SERVICE BULLETIN

M1383

2014 TRIKE AND CVO SOFTAIL HYDRAULIC CLUTCH - SAFETY RECALL 0160

Figure 1. Recall Kit 91500069

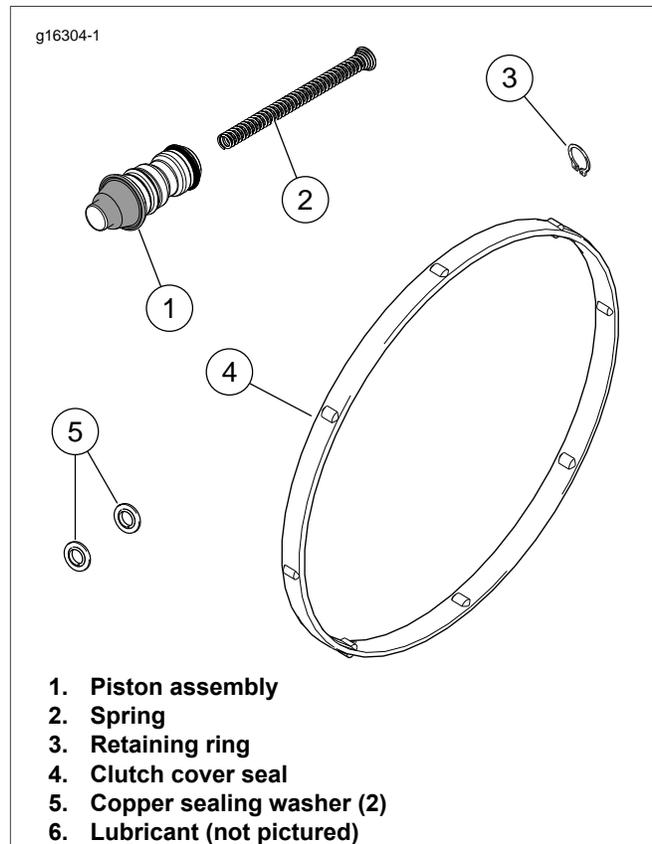
These motorcycles may develop a tear in the primary cup (seal) on the master cylinder piston. If this condition occurs the system may lose the ability to maintain enough lift to keep the clutch disengaged. If this condition remains undetected, it could allow the motorcycle to "creep" forward from a stop, which could lead to a loss of control of the vehicle possibly causing a crash.

1. Confirm that the motorcycle is involved in Recall 0160.
2. Obtain the recall kit (Part No. 91500069).
3. Replace the clutch master cylinder piston assembly with parts from the recall kit. This kit is to be used on both original equipment clutch master cylinders and chrome accessory clutch master cylinders (Part No. 41700263 and 41700263A). See CLUTCH MASTER CYLINDER AND RESERVOIR in the service manual.
4. Fill and bleed clutch fluid system. See the service manual.

Do not reuse any parts removed from the master cylinder piston bore. Use only the parts from the kit.
